CITY OF SOUTH ST. PAUL MEETING AGENDA

A. Camber Hill Townhomes Renovation Project Development Application

PLANNING COMMISSION AGENDA REPORT

Re: Camber Hill Townhome Renovation Project
Site Plan Review

DRAWING TITLE:
**PHASING PLAN
(FOR REFERENCE ONLY)**

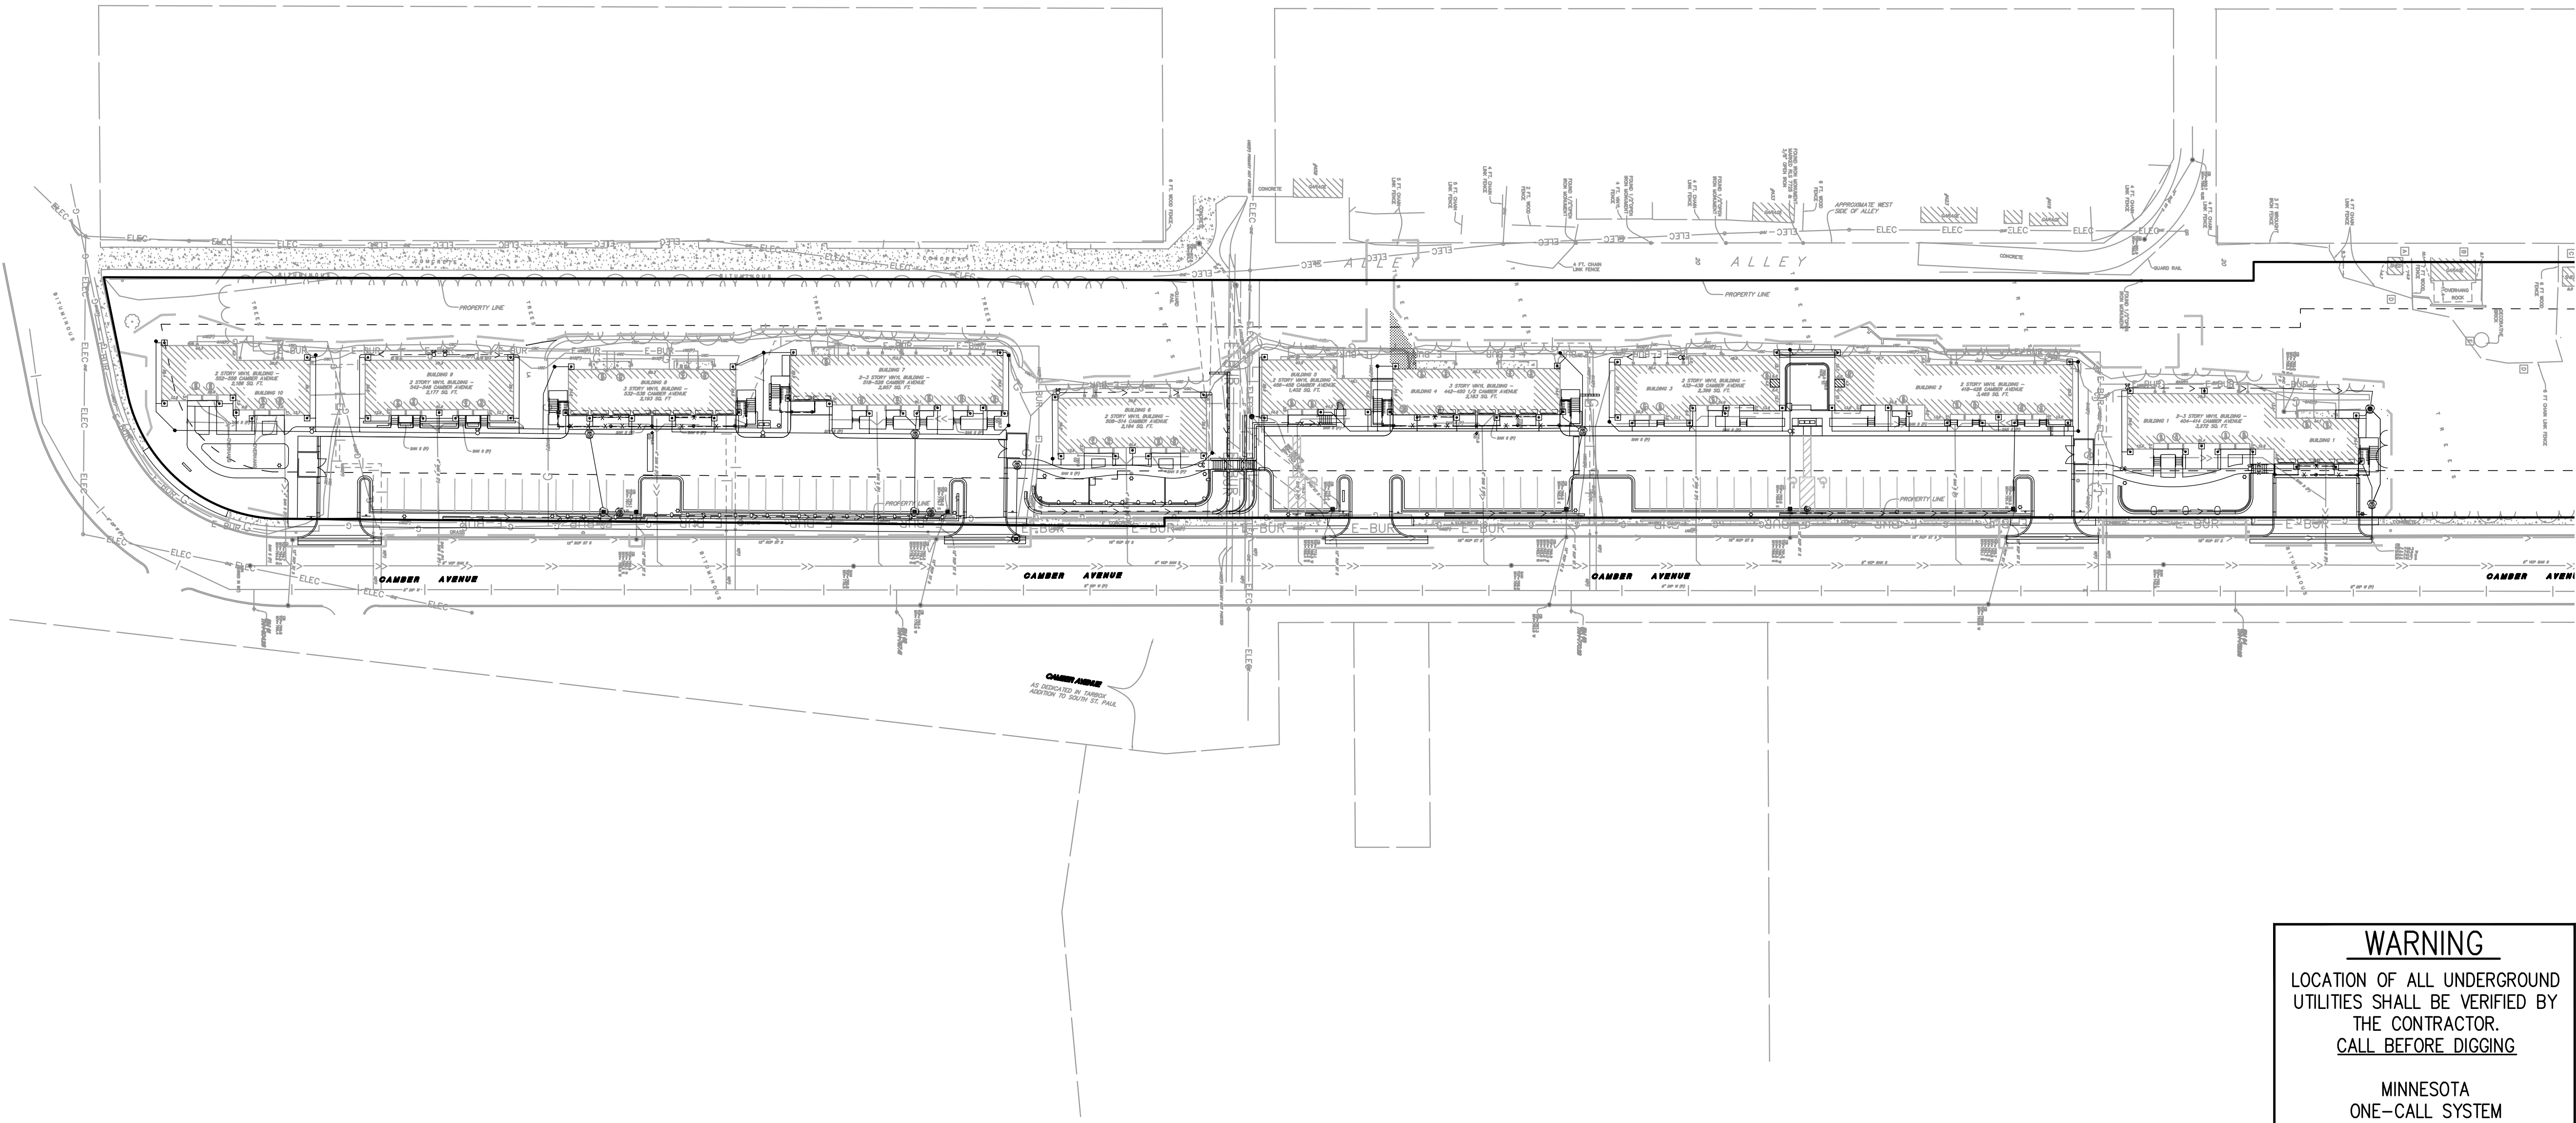
1. The existing 20-ft wide storm sewer easement does not fully encompass the existing storm sewer south of Building 5. Applicant to vacate the easement that does not contain the storm sewer and establish a 20-ft wide easement that follows the centerline of the existing storm sewer.
2. The Phasing Plan does not indicate any phases for the work.

**SURFACING & LAYOUT
PLAN**

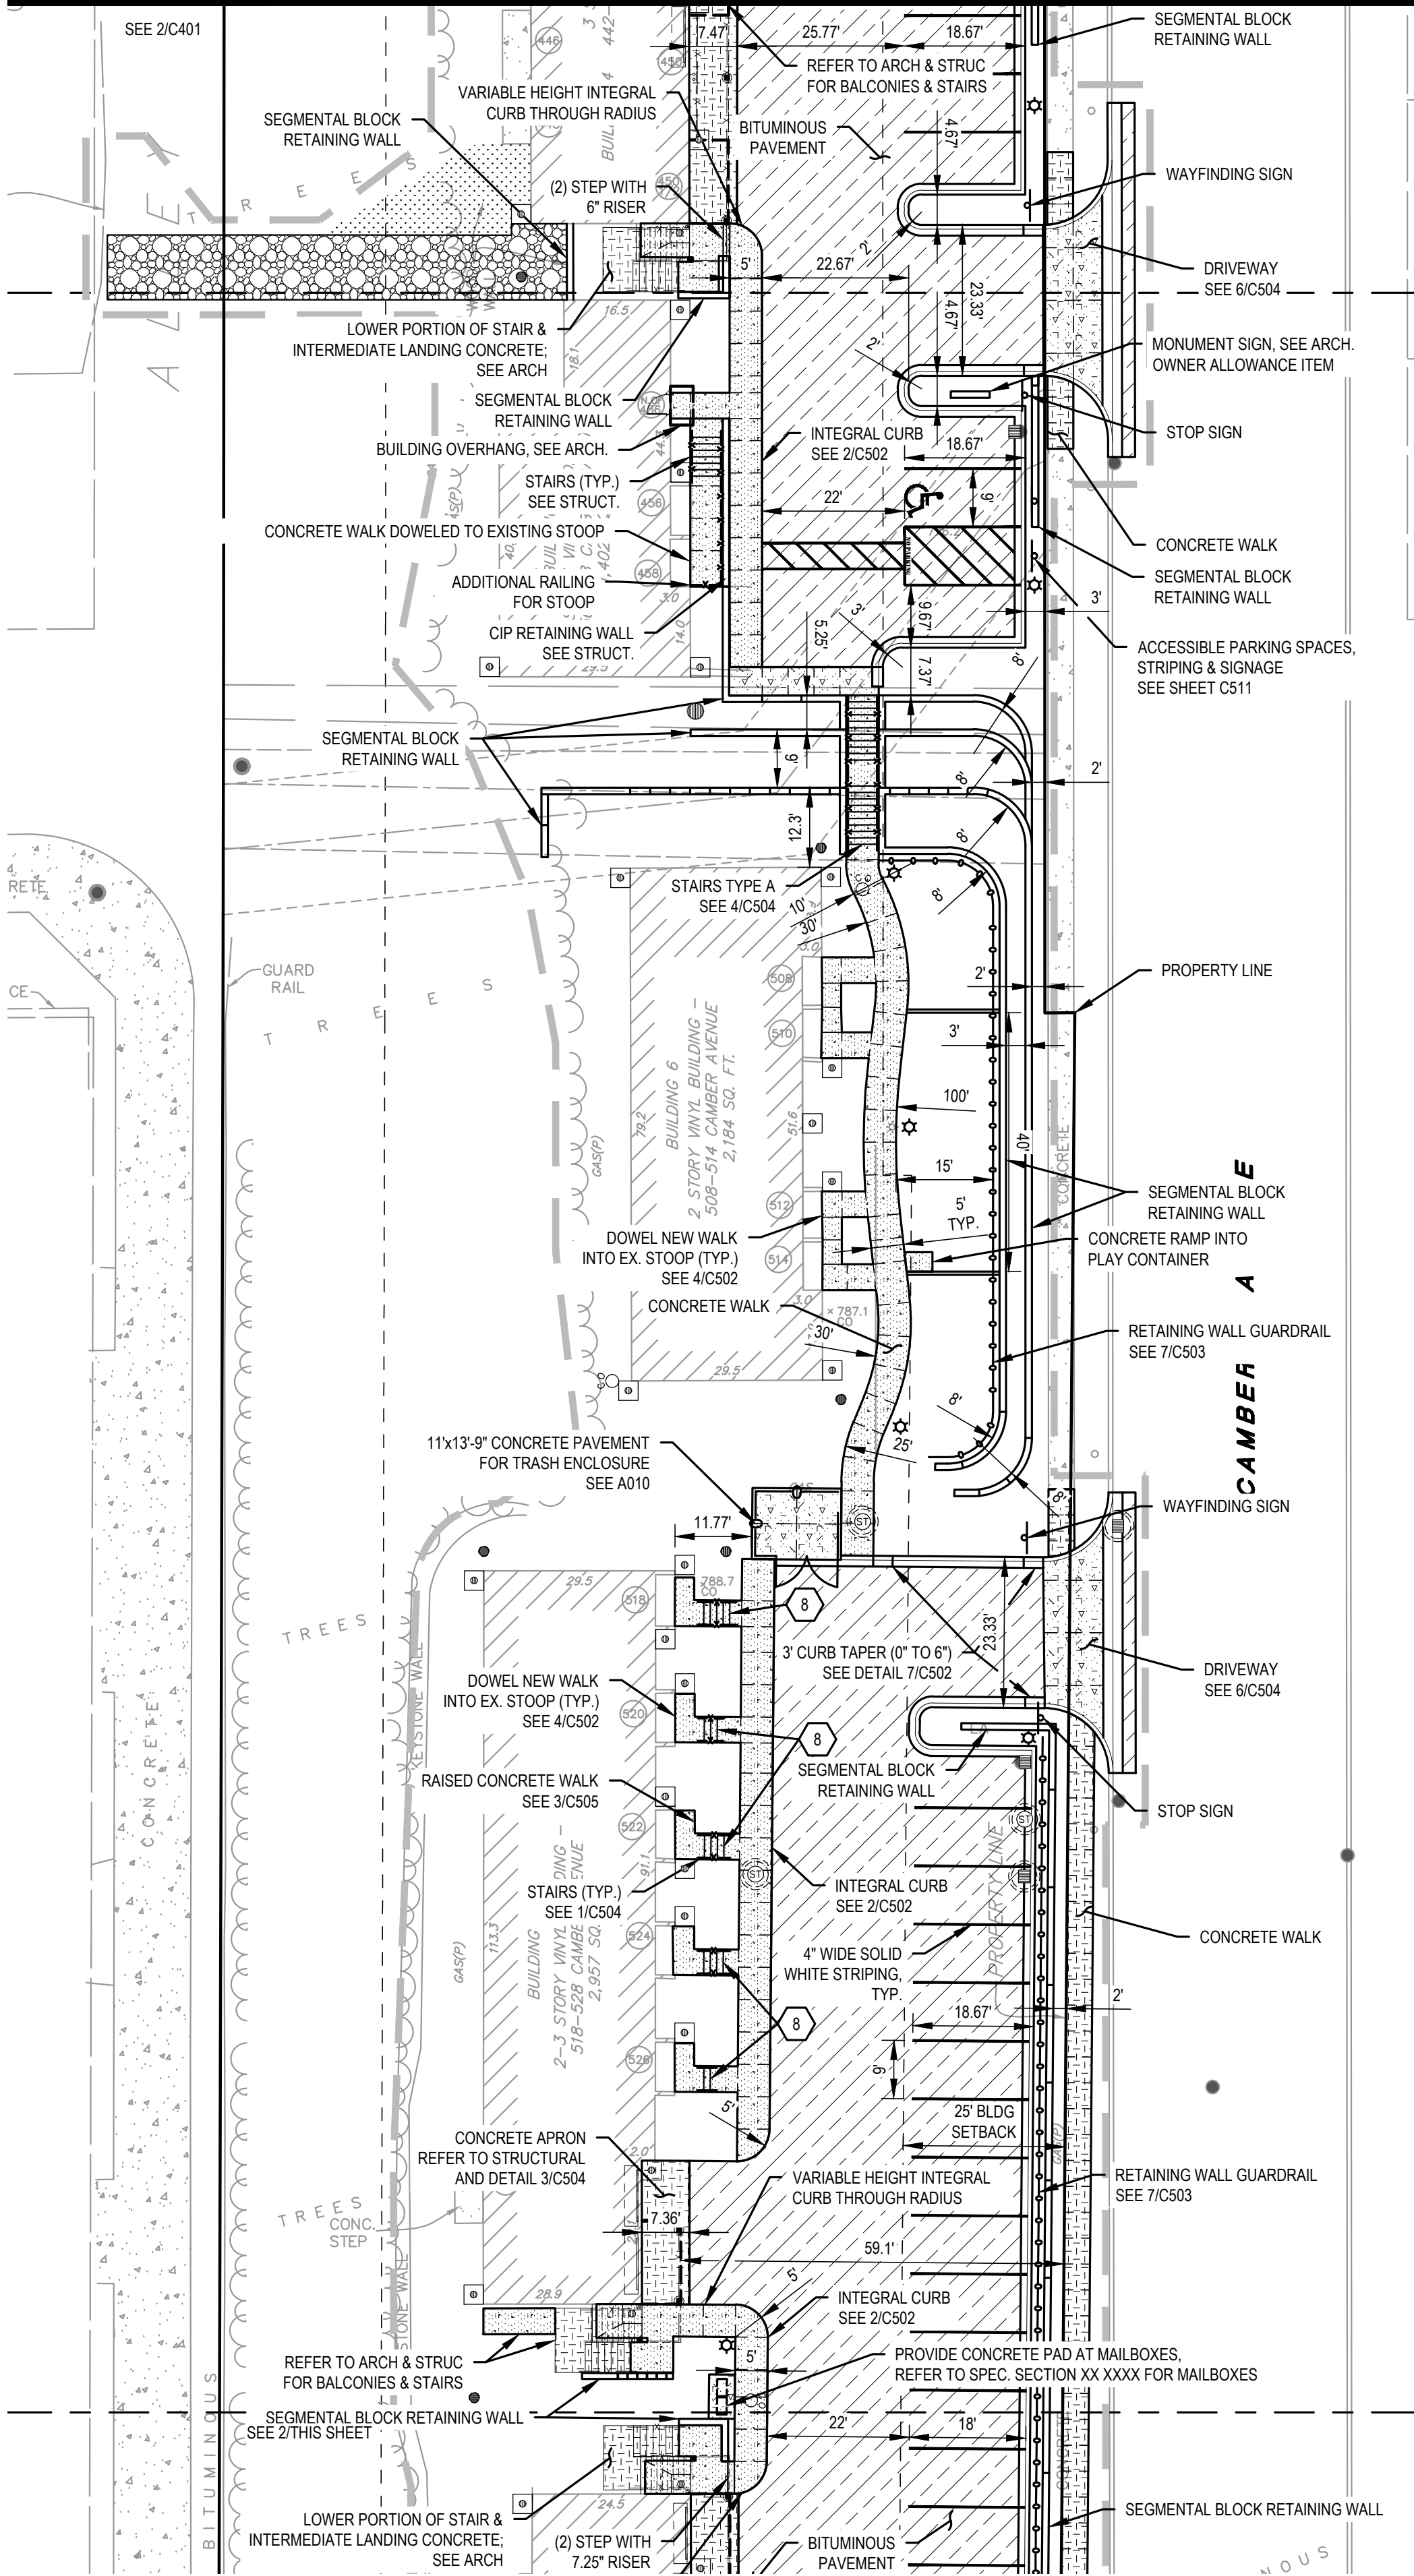
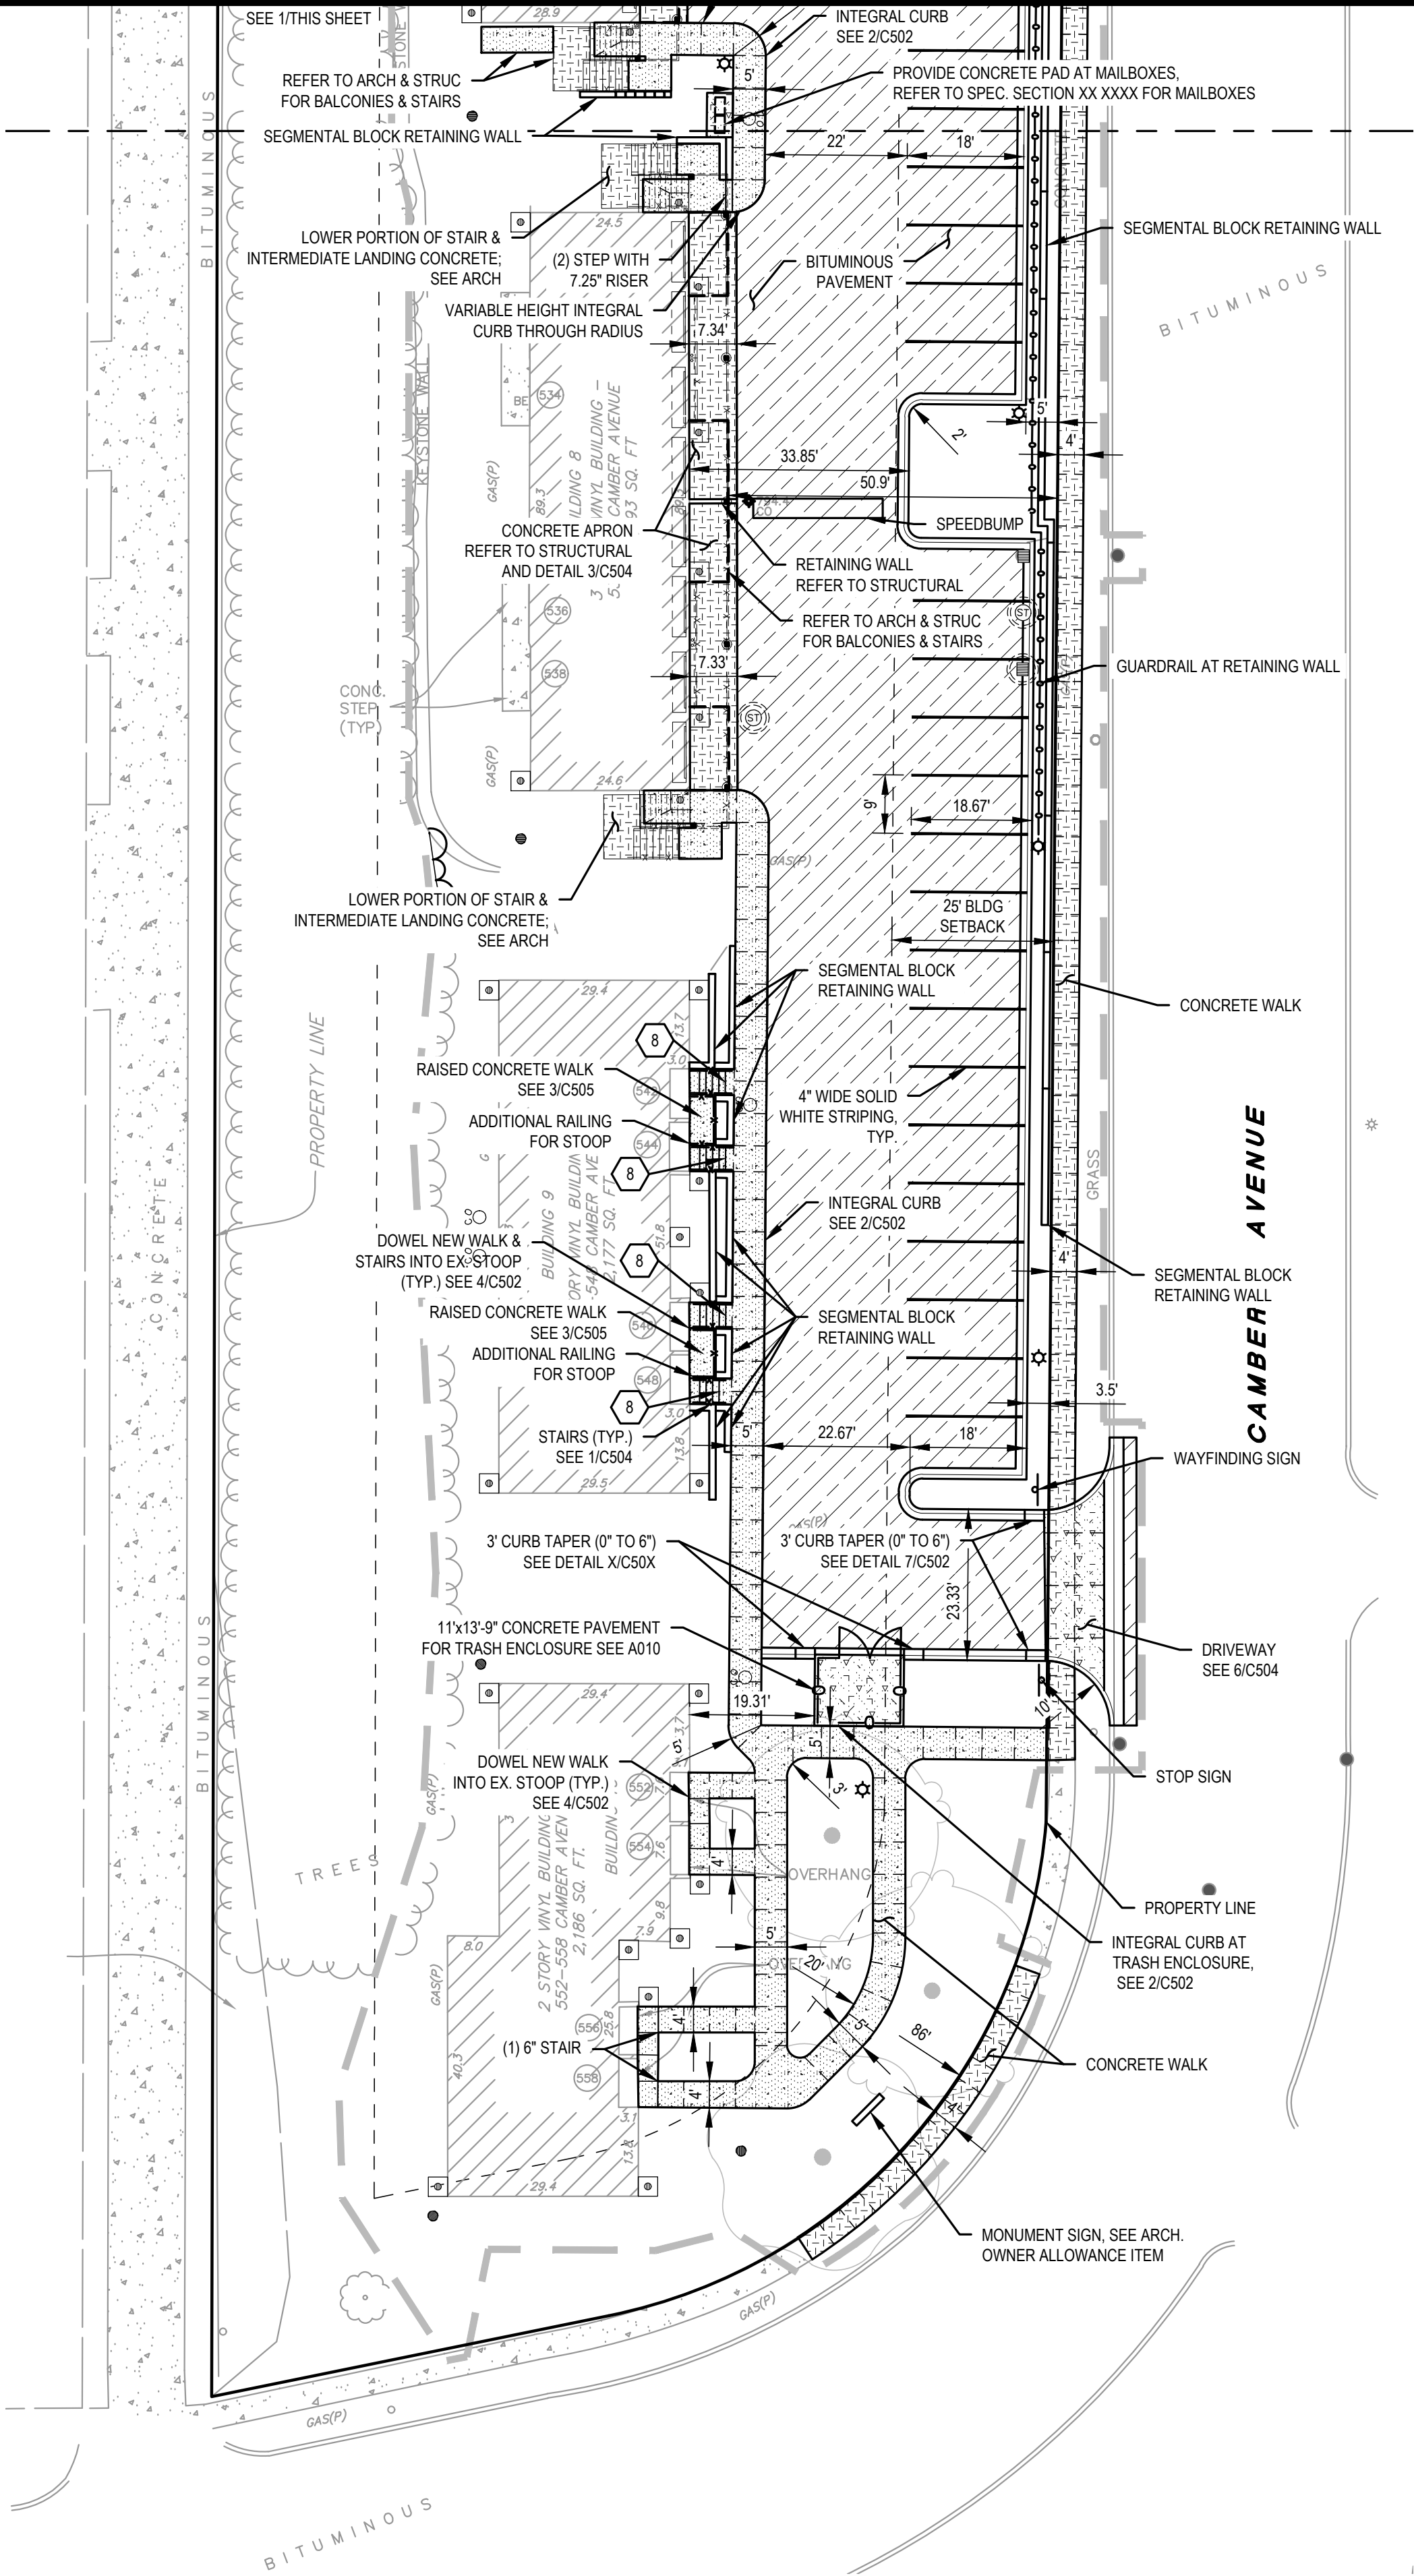
2. Sidewalk within the City's right-of-way shall be constructed per City Standard Detail Plate STRT-3 (attached). Applicant to note that sidewalk through a driveway entrance is to be 6" thick at a minimum.
3. Applicant to review and possibly adjust the proposed monument sign location near Building 5 so that it does not block the view of the proposed stop sign.
4. Applicant to clarify if sidewalk adjacent to the buildings are supposed to have the same hatch as the sidewalk in the City right-of-way.
